ADDENDUM NO.: 01
PROJECT NAME: North Park Village (NPV) Chapel-Building F (Bid Package 1 - Roofing)
PROJECT NO.: 04037
DATE OF ISSUE: 6/7/2023

NOTICE OF CHANGES, MODIFICATIONS, OR CLARIFICATIONS TO CONTRACT DOCUMENTS

NORTH PARK VILLAGE- BUILDING F (CHAPEL)

Sheet: **G-002**

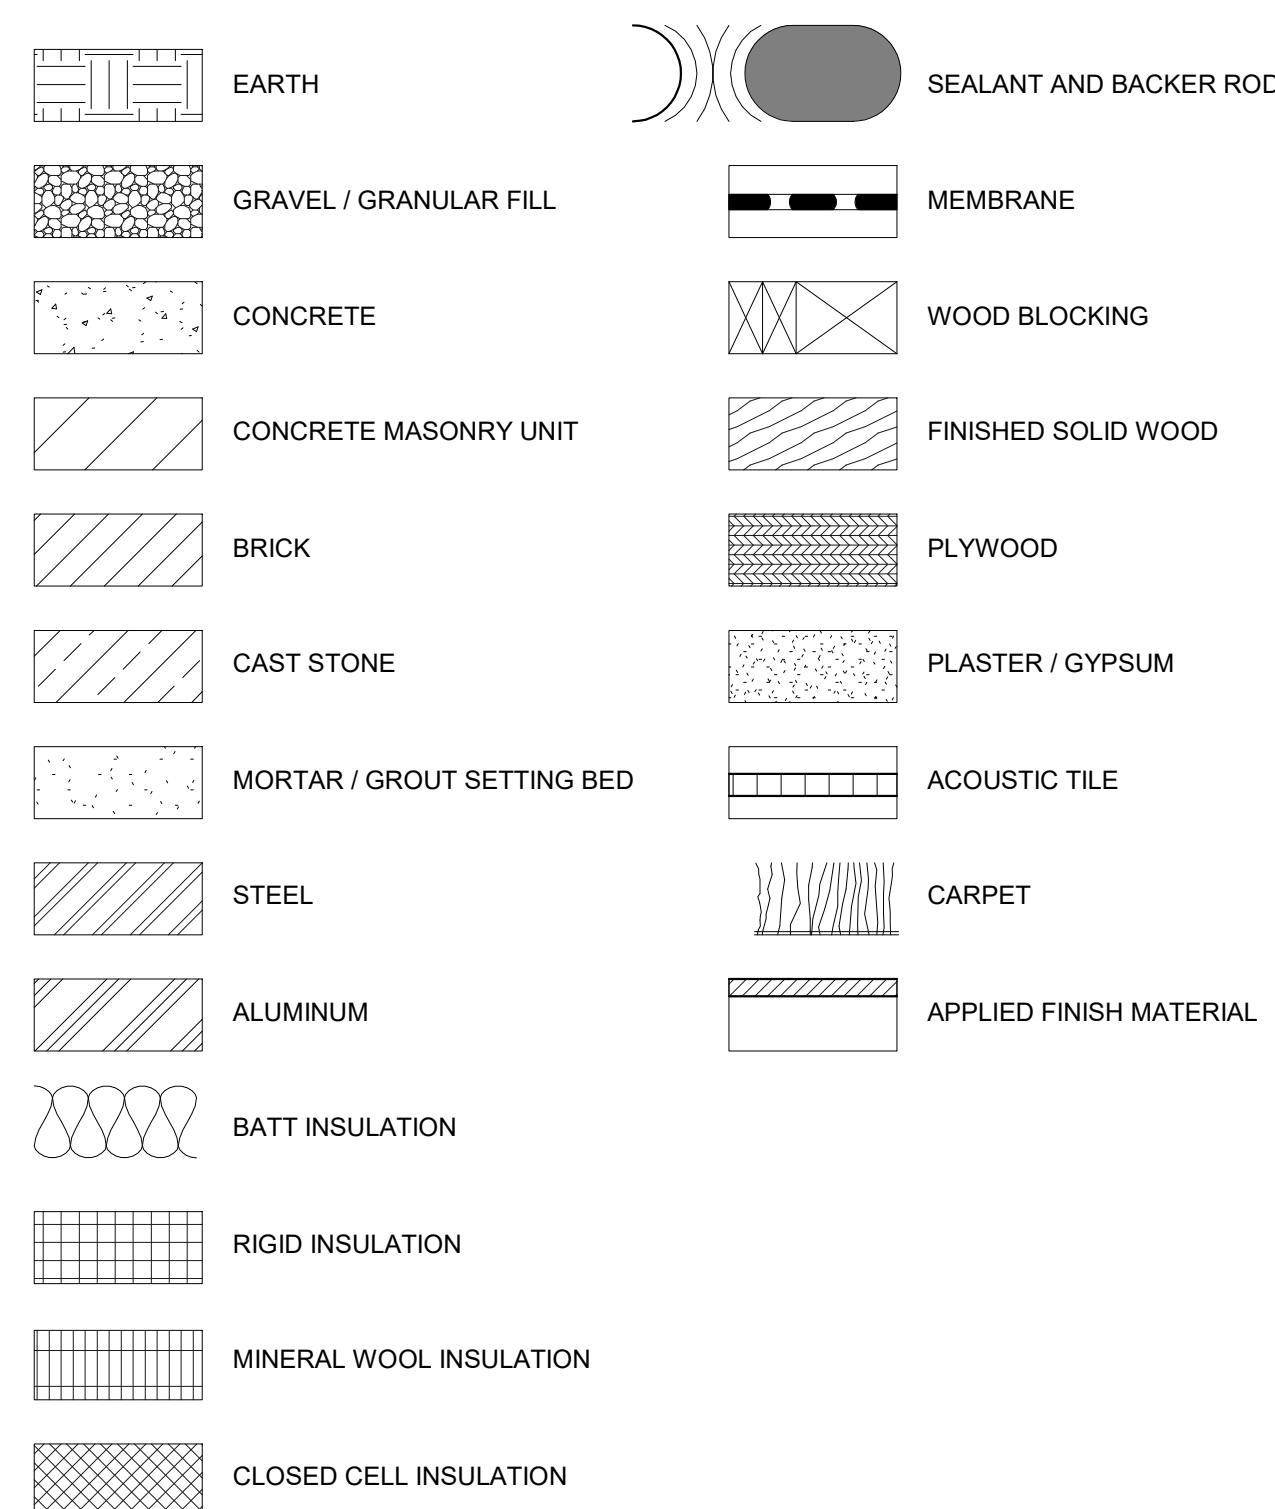
Change 2 **Revised** G002 General Notes, changed to include tree pruning guidelines.

Question 1 Will the trees be removed at the north end of the building so we can access our work? Will this be by others or does it need to be included in our price.

Answer: No, the existing trees do not need to be removed. Please refer to Note 6 on Sheet G-002 General Notes for Existing Site Elements. If tree pruning is required, please refer to Tree Pruning Notes which have been added to Sheet G-002. Sheet G-002 has been revised and is included in this addendum.

- ALL PRUNING SHALL BE PERFORMED BY A CERTIFIED ARBORIST
 - PRUNE REMAINING TREES AFFECTED BY TEMPORARY AND NEW CONSTRUCTION AS REQUIRED.
 - PRUNE REMAINING TREES TO COMPENSATE FOR ROOT LOSS CAUSED BY DAMAGING OR CUTTING ROOT SYSTEM

- PRUNE TREES ACCORDING TO ANSI A300 PART 1 AND ANSI Z133.1
 - CUT BRANCHES WITH SHARP PRUNING INSTRUMENTS. DO NOT BREAK OR CHOP.
 - BRANCHES REMOVED FROM TREES ARE TO BE DISPOSED OF.

- ALL PRUNING AND TRIMMING TO BE IN COMPLIANCE WITH REQUIREMENTS OF THE BUREAU OF FORESTRY

1 SITE PLAN
SCALE: 1/16" = 1'-0"

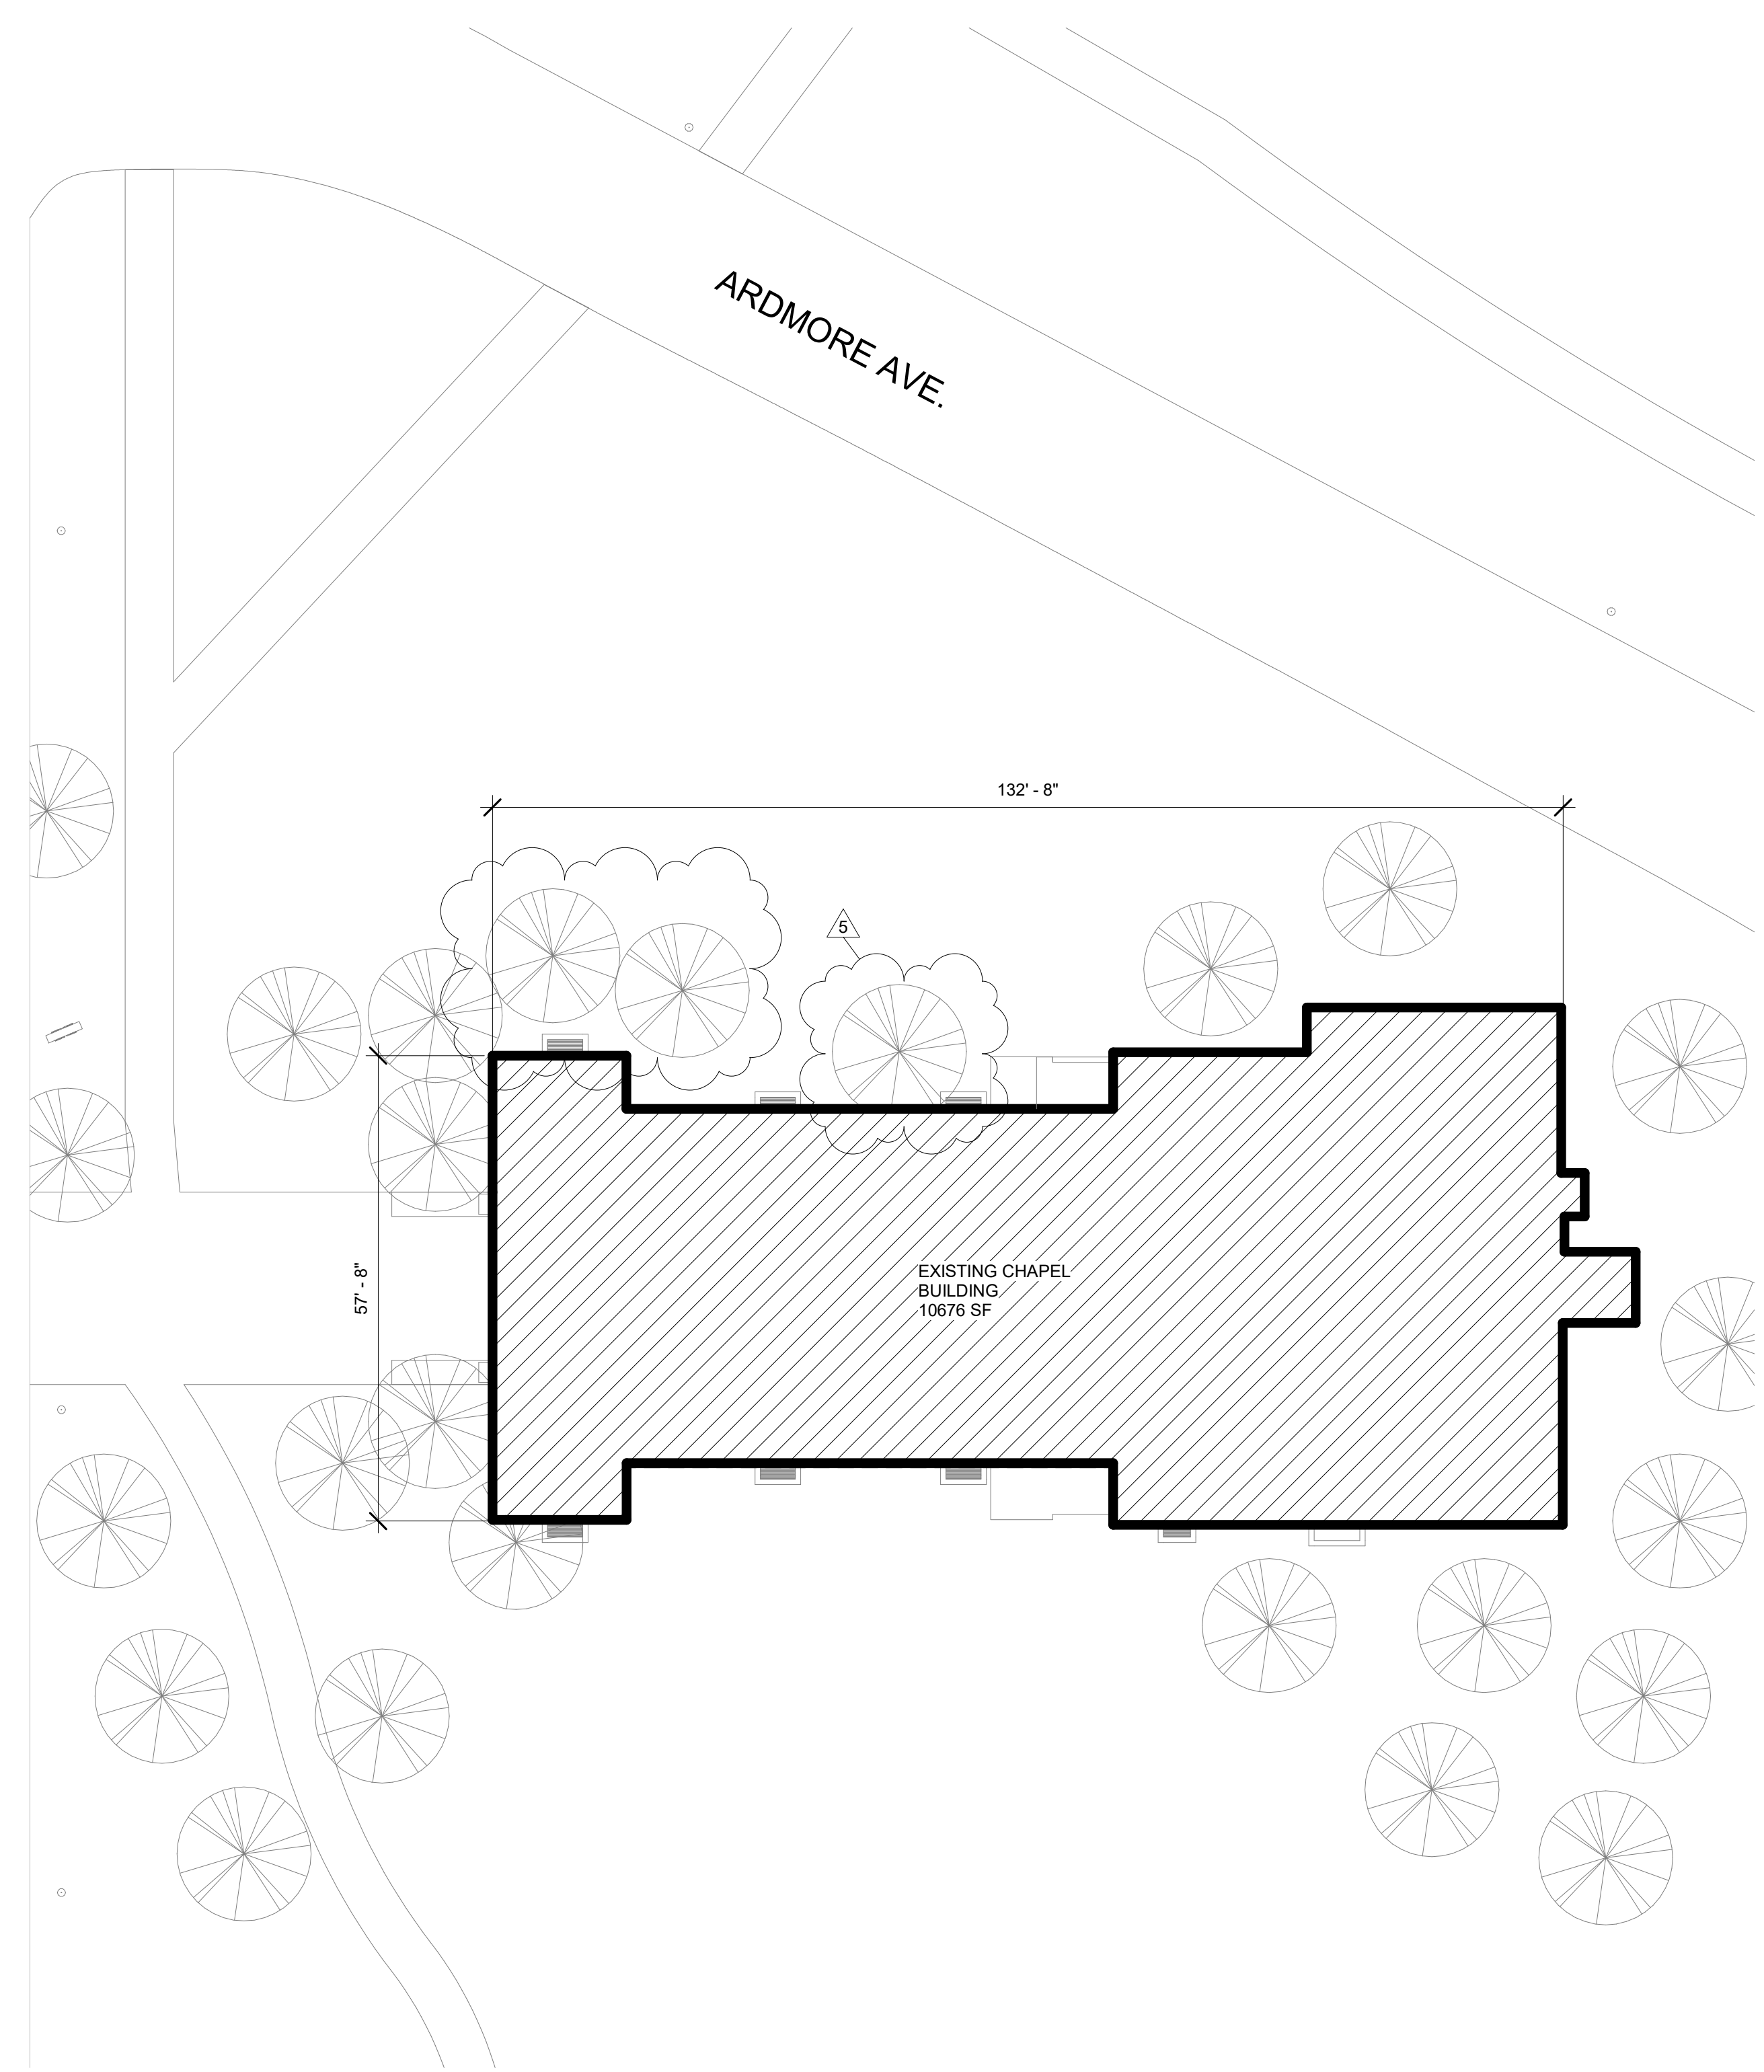
Change 3 **Revised** G-010 Site Plan, updated to reflect two additional existing trees on the north of the chapel.
